Southern Nuclear  
Operating Company, Inc.  
42 Inverness Center Parkway  
Birmingham, AL 35242

ND-14-0588  
10 CFR 50.90  
10 CFR 52.63

Southern Nuclear Operating Company  
Vogtle Electric Generating Plant Units 3 and 4  
Request for License Amendment and Exemption Regarding  
Passive Core Cooling System (PXS) Condensate Return (LAR-13-024)

ND-14-0588  
Enclosure 3  
Proposed Changes to the Updated Final Safety Analysis Report (LAR-13-024)

**The UFSAR Section 6.3, Figure 6.3-2 is revised to become Figure 6.3-1 (Sheet 2 of 3), and revised as indicated below.**

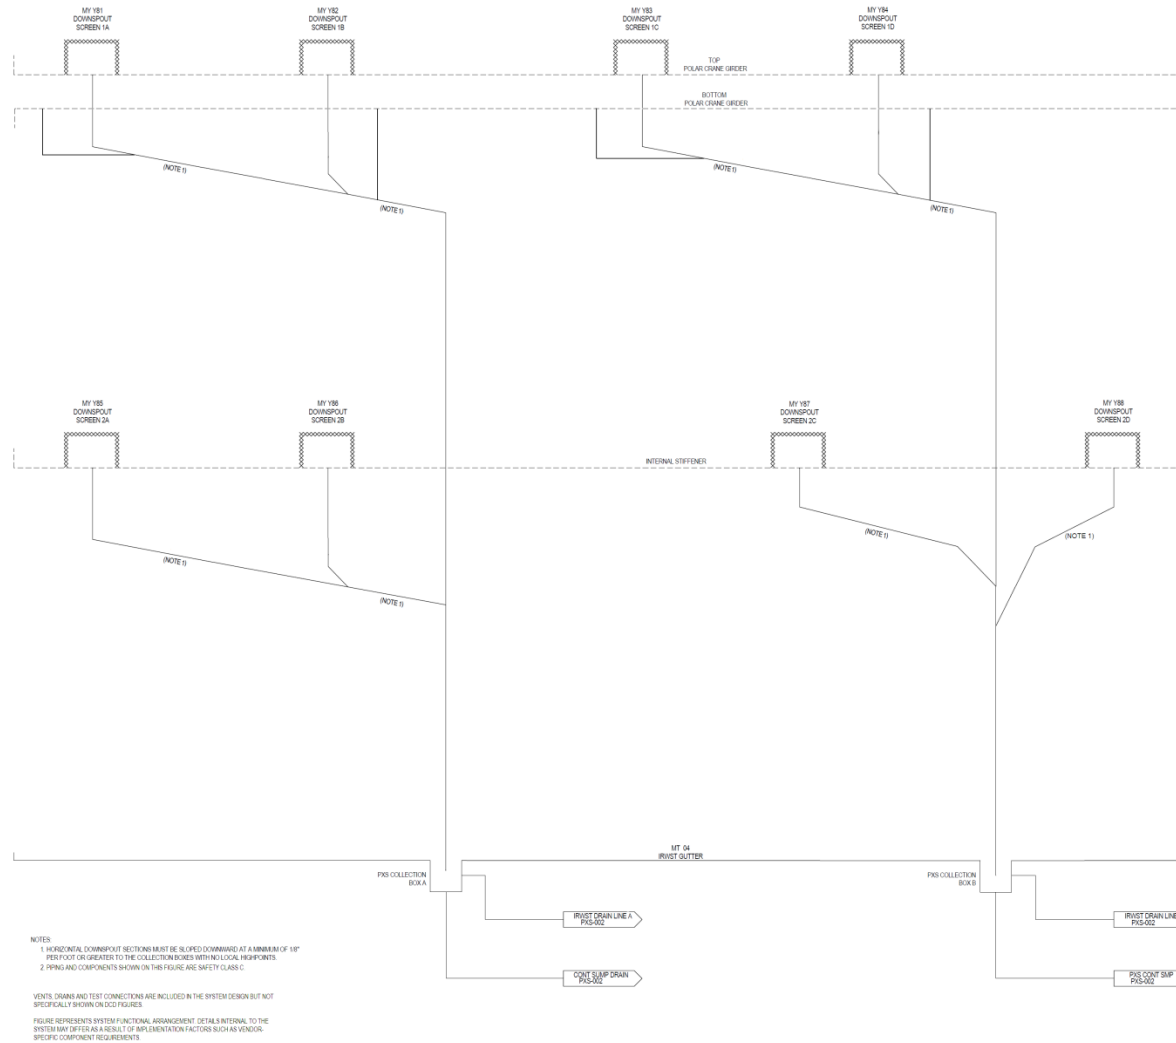
- Figure 6.3-2 is relabeled “Figure 6.3-1 (Sheet 2 of 3).” On relabeled Sheet 2, the IRWST gutter is relocated to a new sheet 3 of the PXS P&IDs. Sheet 2 is modified to include continuation flags for condensate returning to the IRWST originating from PXS Collection Boxes A and B in the IRWST gutter.

The UFSAR Section 6.3, Figure 6.3-1 (Sheet 2 of 3) [that was Figure 6.3-2] is revised to relocate the IRWST gutter to a new sheet 3, and to include continuation flags for condensate returning to the IRWST originating from PXS Collection Boxes A and B in the IRWST gutter as shown below.

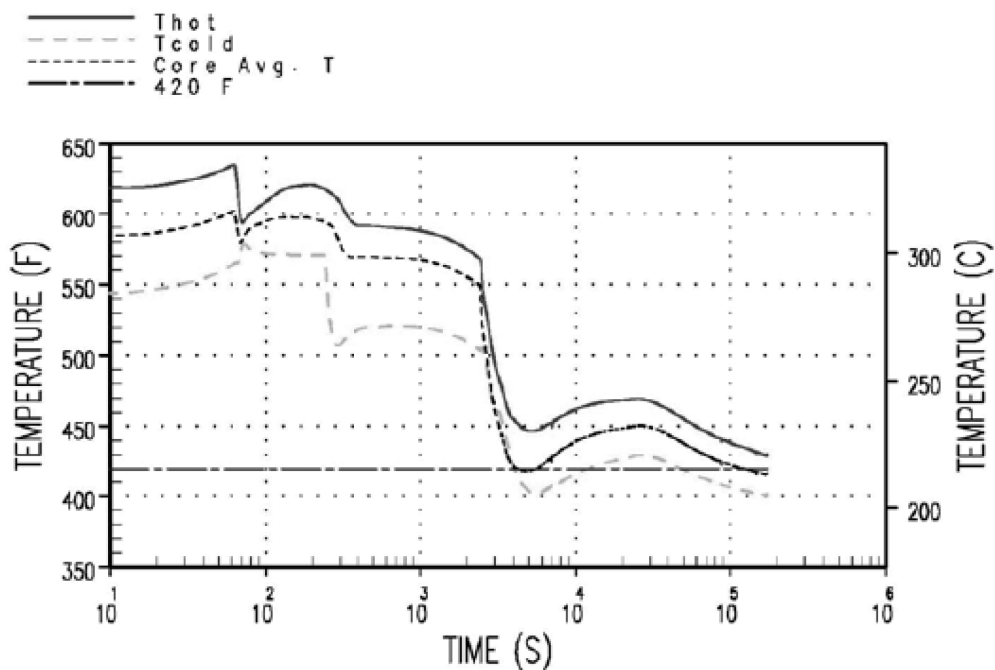
Once actuated, at about ~~600~~ 2,400 seconds, the CMTs operate in recirculation mode, injecting cold borated water into the RCS. In the first part of their operation, due to the cold flow rate, the CMTs operate in conjunction with the PRHR to reduce RCS temperature. Due to the primary system cooldown, the PRHR heat transfer capability drops below the decay heat and the RCS cooldown is essentially driven by the CMT cold injection flow. However, at about ~~3,500~~ 5,000 seconds, the CMT cooling effect decreases and the RCS starts heating up again (Figure 19E.4.10-1). The RCS temperature increases until the PRHR HX can match decay heat. At about ~~31,000~~ 34,500 seconds, the PRHR heat transfer matches decay heat and it continues to operate to reduce the RCS temperature to below 420°F within 36 hours. As seen from Figure 19E.4.10-1, the cold leg temperature in the loop with the PRHR is reduced to 420°F within 48,600 ~~at 82,600~~ seconds, while the core average temperature reaches 420°F within 124,400 ~~423,600~~ seconds (approximately 34.6 hours).
